CAMPAIGN FOR THE PROTECTION OF RURAL WALES

APPENDIX 3

ERRORS, PROBLEMS & METHODOLOGY in the EVIDENCE for ENERGY POLICY in draft NDF 2019

ARUP STAGES 1 AND 2: Identification of priority areas, application of constraints, refinement.

Figure 2: Distances at which average medium magnitude of visual effect occurs for different heights of turbine. Source: Commissioned Report for NRW Evidence Series, Report Number 31515

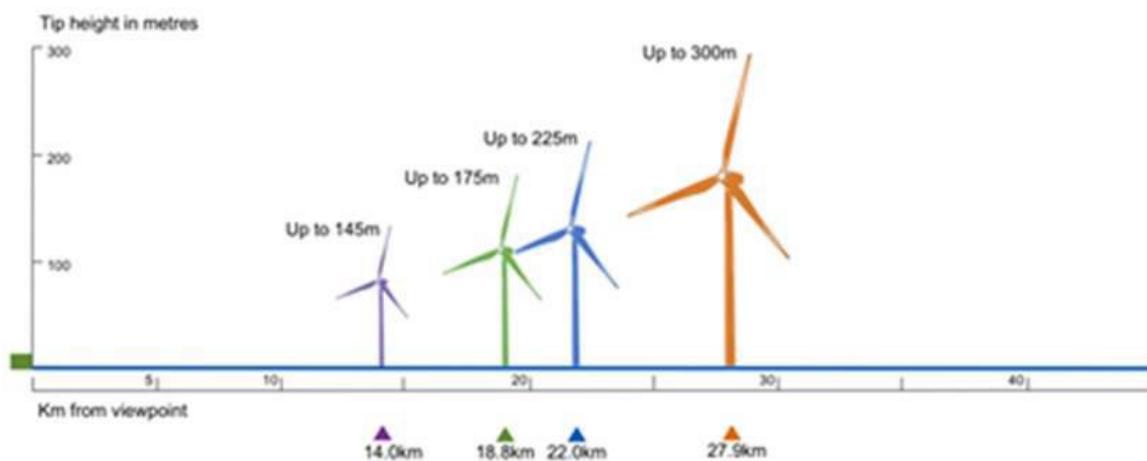
It is acknowledged that using the NRW Ready reckoner of visual effects related to turbine size report to inform the identification of visual study areas has certain limitations. For example, the number of Seascape, Landscape and Visual Impact Assessments (SLVIAs) used to inform the report was small due to the availability of relevant SLVIAs. However, given the strategic nature of this study it is considered that the use of the Ready reckoner is acceptable.

The visual study areas have been focussed on the range of distances linked to turbine height which have been shown to result in impacts of medium magnitude or above, see Figure 2.

The visual study areas for turbines up to 150m and 250m have been identified by interpolating between the range of turbine heights given in NRW's Stage 1 ready reckoner report, which gives:

- 15km (rounded up from 14.75km) buffer for turbines up to 150m.
- 24km for turbines up to 250m.

9. ARUP 2: p148 Fundamental errors in ‘Primary settlements – population’ map (extract below):

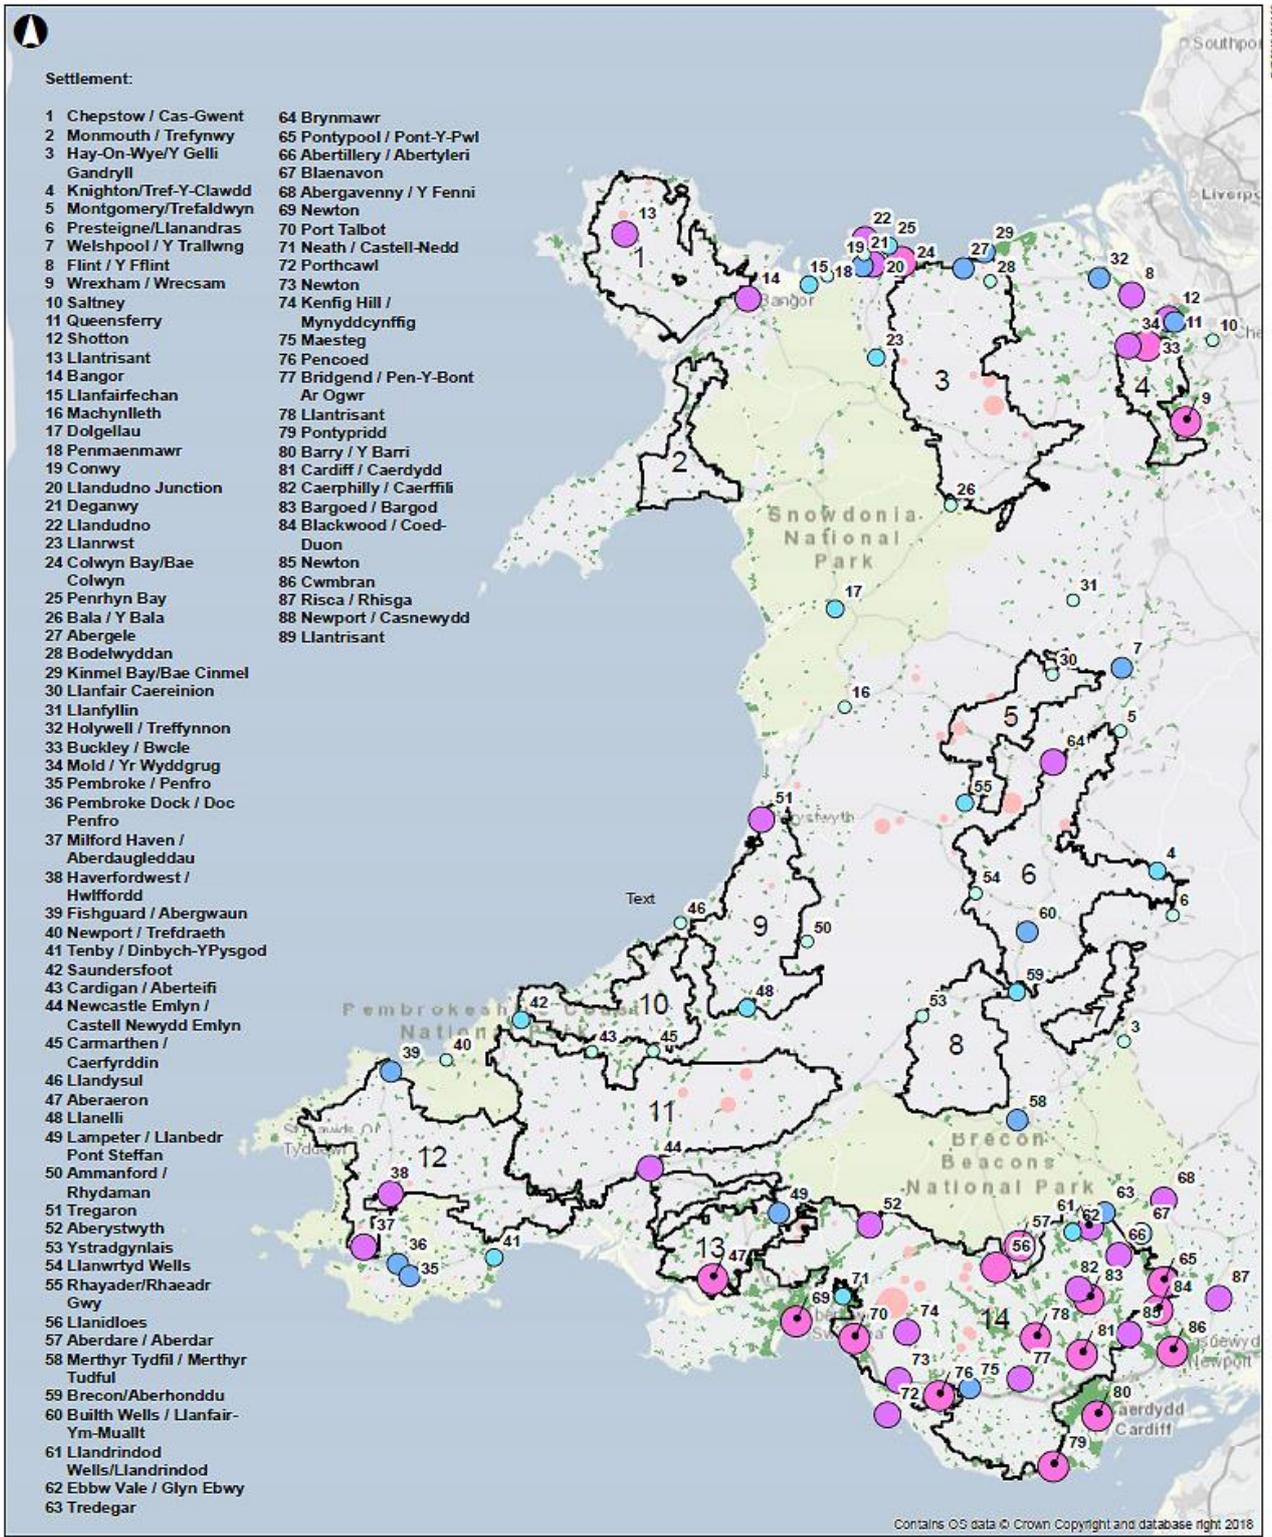
There are fundamental inaccuracies: 5 of the named settlements are not mapped at all - 1, 2, 41, 88, 89; around half of the settlements mapped are incorrectly identified. These are fundamental errors which it is astonishing to find in finalised documents put out by Welsh Government for public consultation as evidence for policy which will massively impact the whole of rural Wales for the foreseeable future. This has to cast serious doubt on the adequacy/accuracy of ARUP reports as a whole as an evidence base for major policy change. See map reproduced below.

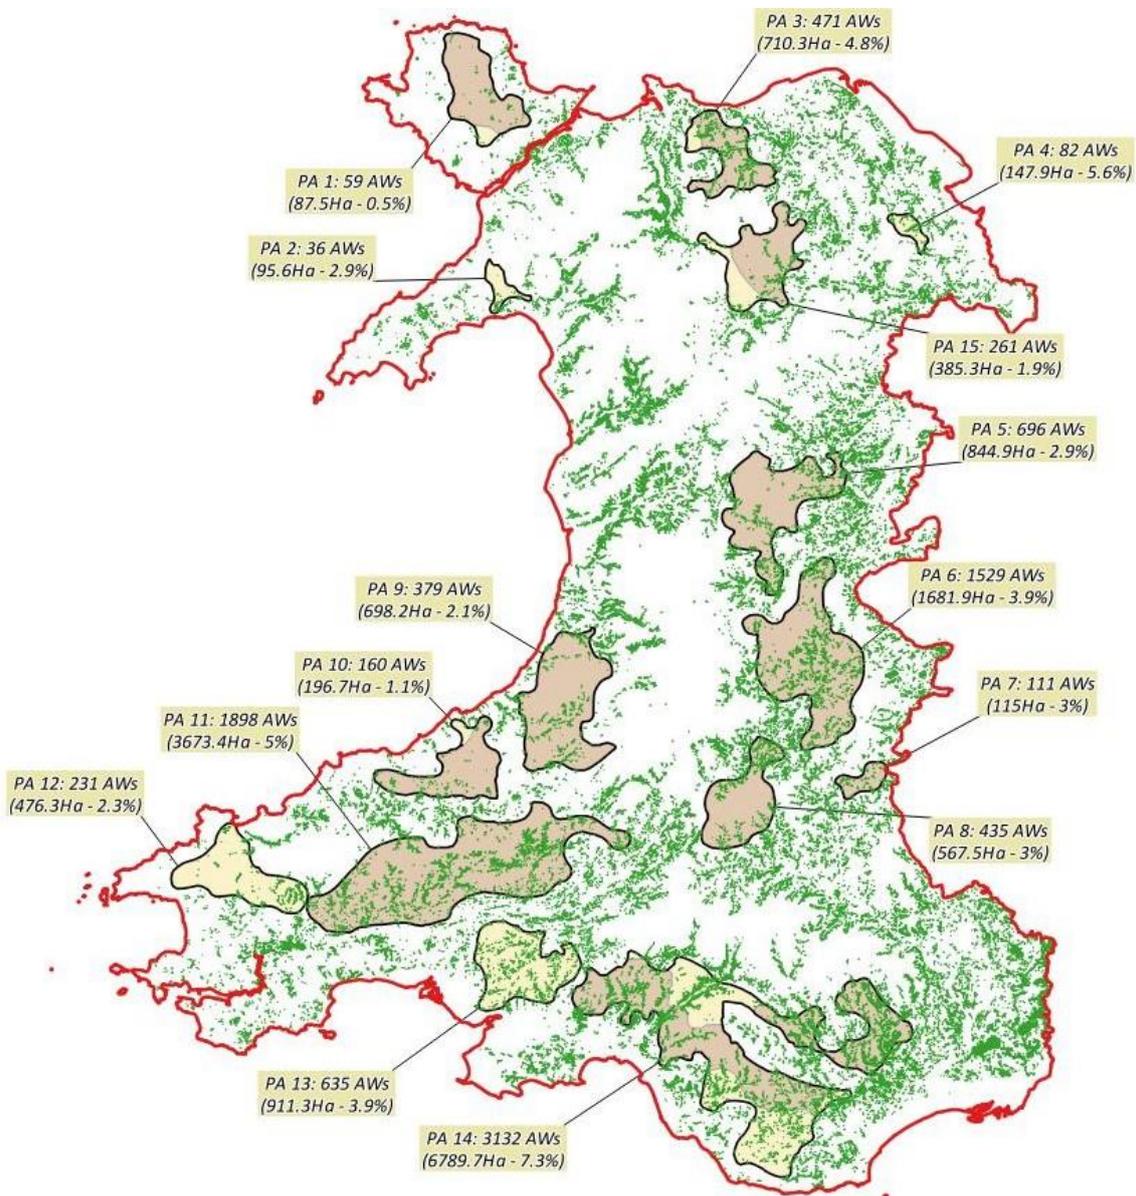
Identified as a 'fixed constraint' in ARUP 2 Table 2 'Fixed Constraints' p 10, but there is no mapping of ancient woodland, and no exclusion of ancient woodlands in the definition or refinement of PAs. The relaxed planning regime, and presumption of approval, (see NDF Policy 10) proposed within PAs will not protect this important and irreplaceable asset. See map below which indicates the number and extent of Ancient Woodlands contained within PAs.

1. Inadequate buffering of protected environmental sites: Elenydd Mallaen SPA buffer

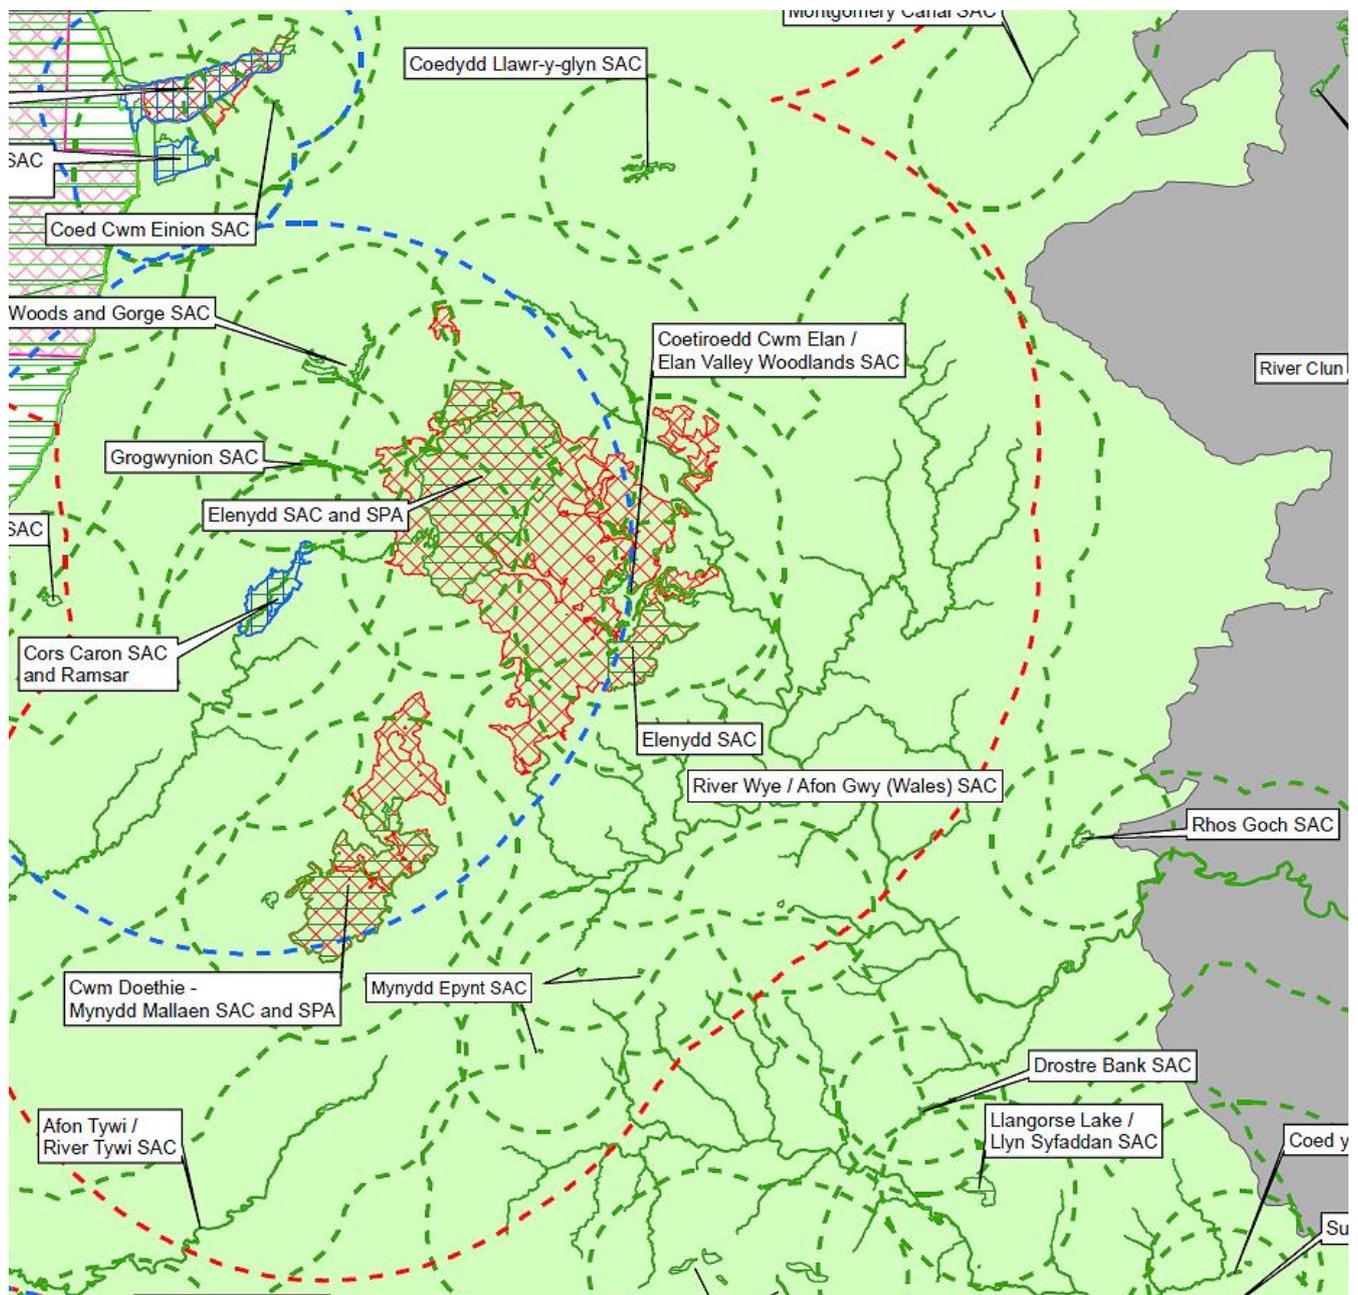
Now see CPRW map below, which indicates the correctly drawn **20km** buffer around the Elenydd-Mallaen SPA on a base map which includes the refined PAs, and so indicates which PAs lie **within** the foraging buffer of the Elenydd-Mallaen SPA i.e. parts of PAs 5 and 11, and almost the entirety of PAs 6, 8 and 9.

Note that species within the management plan for the SPA include peregrine (*Falco Peregrinus*). From p7 of the HRA (version 2): ‘...any proposed development that is within 10km of a site supporting peregrine or hen harrier is likely to struggle to pass the HRA test, as it will be difficult to ‘demonstrate beyond reasonable scientific doubt’ that birds associated with the SPA/Ramsar site will not be vulnerable to impacts (such as disturbance or wind turbine/vehicle collision). **This is because the known foraging distances for hen harrier and peregrine from the literature are 10km and 18km, respectively.**’

It’s clear that the HRA Appx B, subtitled ‘Implications for the Natura 2000 network of Priority Areas of Solar and Wind Energy development across Wales – HRA Report’, fails to accurately map the required buffer for this SPA against the locations of refined PAs. In consequence, the HRA does not recognise the fact that PAs and parts of PAs lie entirely within the foraging buffer of the SPA and **the implications of the PAs on the Natura 2000 network are therefore substantially underreported.**

HRA Appx A (Habitats Regulations Assessment: Rules of Thumb) p34 'Figure 2: Detailed view of Natura 2000 sites with site buffers Page 4 of 8': Red dotted line indicates 20km buffer for Elenydd-Mallaen SPA. See extract reproduced from this map below:

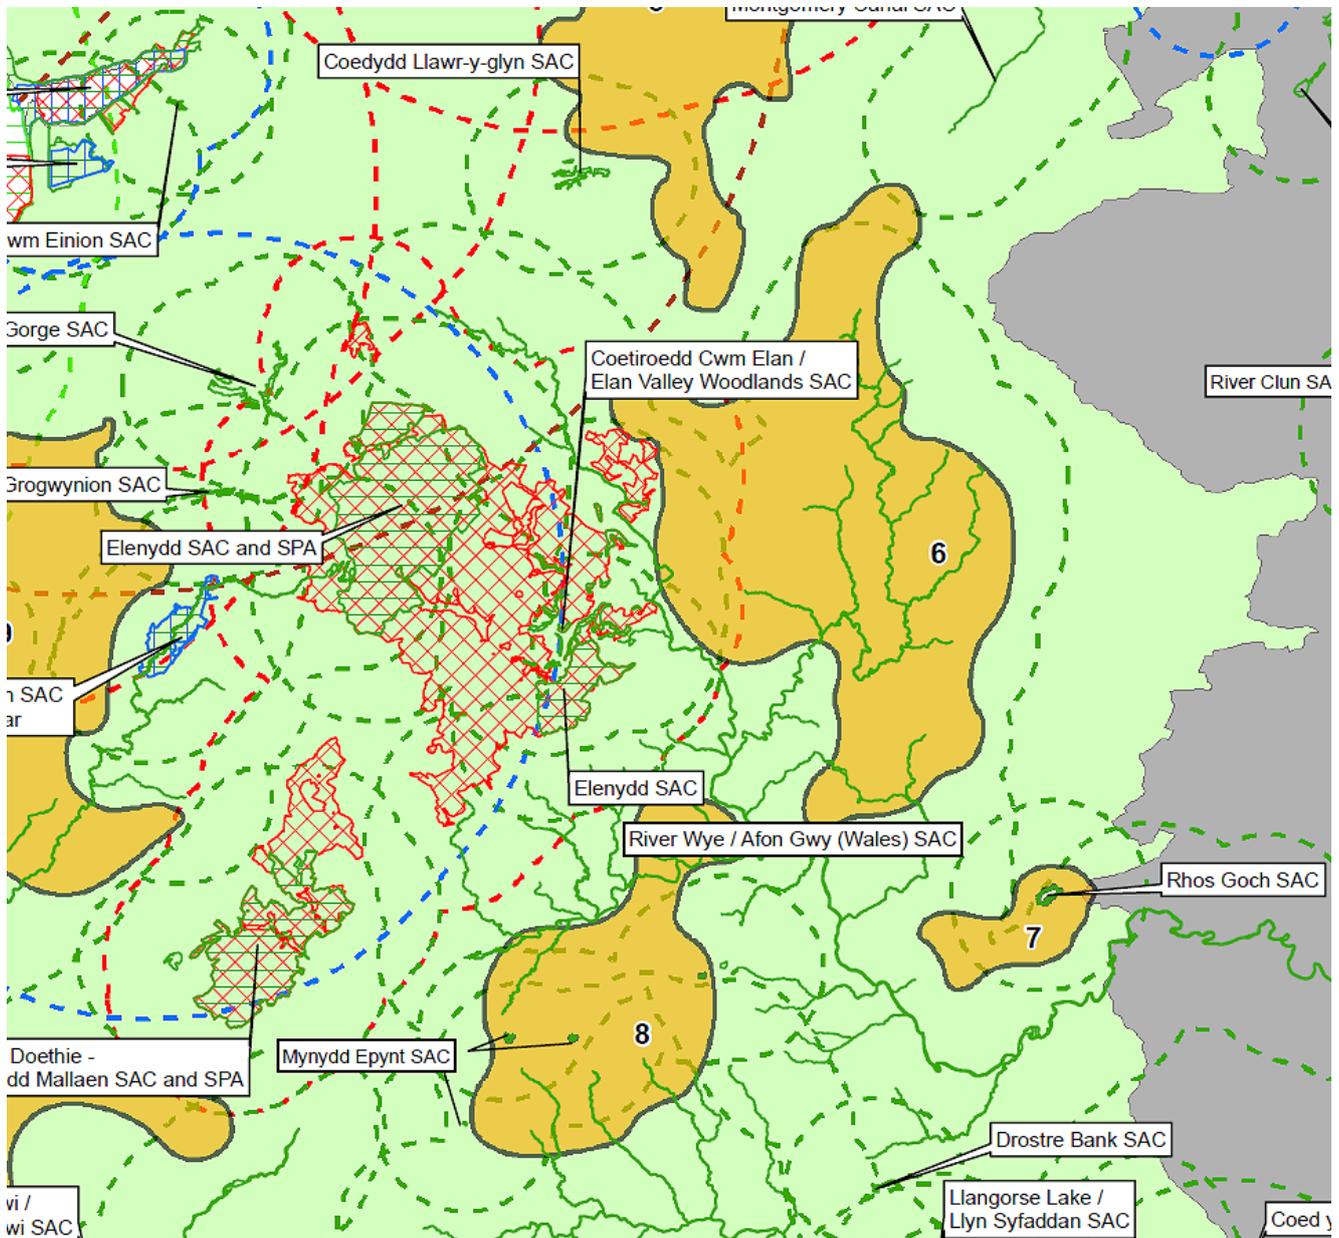
The HRA (Version 2) (p6) states ‘*The buffer distance set for birds is greater than for bats mainly because certain birds associated with SPAs and Ramsar sites (e.g. raptors, wildfowl & waders, etc.) tend to readily fly greater distances as part of their foraging behaviour. Thus, birds associated with a designated site are certainly not confined to the boundaries of that location and will often fly some distance from it to feed, roost or breed. This is the basis of the concept of ‘functionally-linked land’ and the fact that HRAs of SPAs need to take into account*

the fact that birds from the designated population will often spend time outside the designated area. Whilst this is very unlikely to be an issue for solar farms (although the presence of such features could displace birds from areas they would previously have used), there certainly is a risk of mortality associated with wind farms, even if they are some distance from the border of a Natura 2000/ Ramsar site supporting birds. **The buffer zone for SPAs (and for Ramsar sites where the qualifying features include bird species) has therefore been set at 20km.'**

And further on: 'These buffer zones are very important with regard to future consideration of wind and solar farm development both within and beyond the new Priority Areas for Solar and Wind Energy. Essentially, these buffers should aid the HRA Screening process for subsequent renewable development proposals. Any proposed wind or solar development that is outside the buffer zone for any Natura 2000/ Ramsar sites can be screened out of HRA, as it can be assumed that significant impacts are extremely unlikely. By contrast, any proposed wind or solar farm within a buffer will need to be screened.'

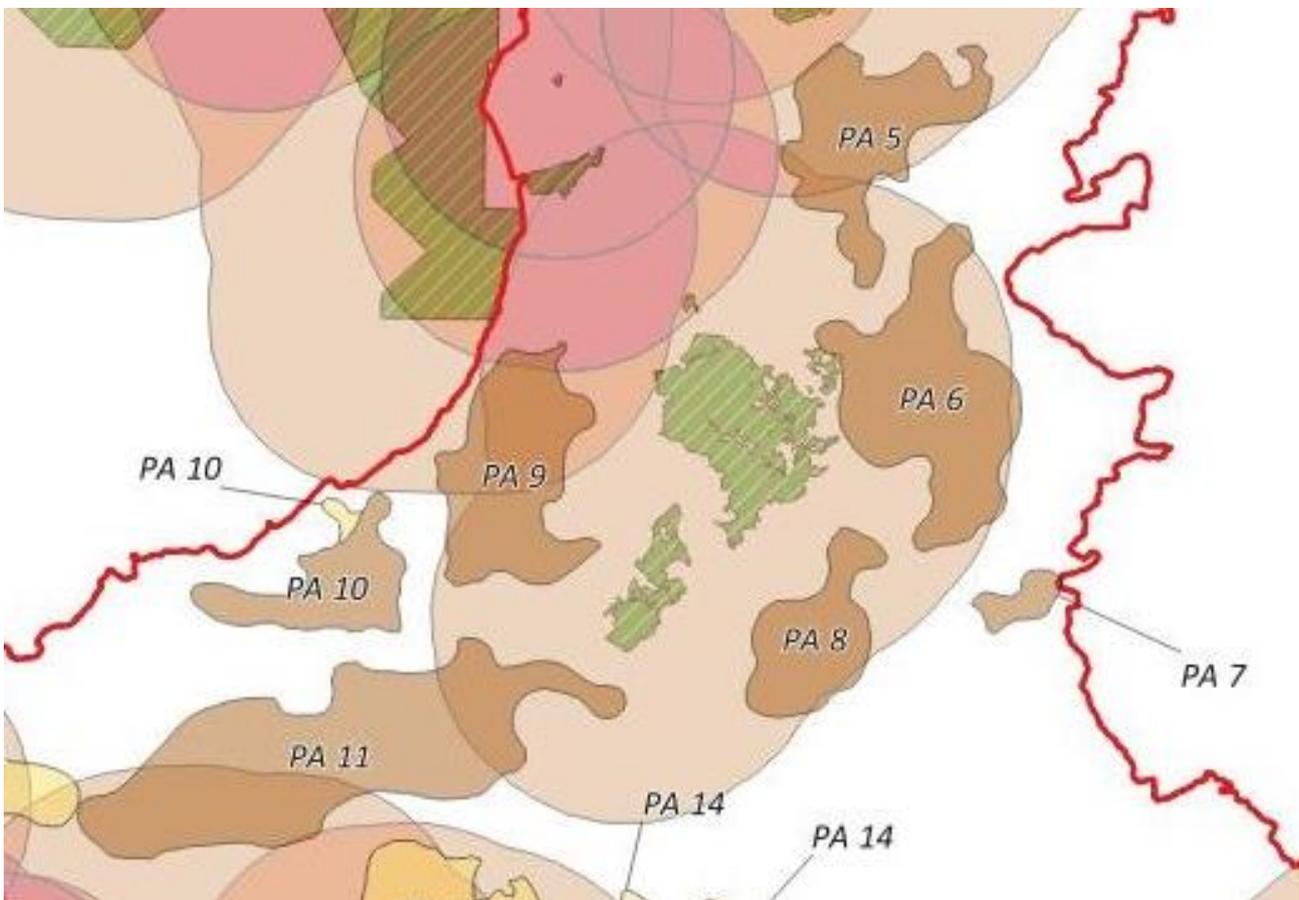
See extract reproduced from this map below, and contrast dotted red line buffer with map above:
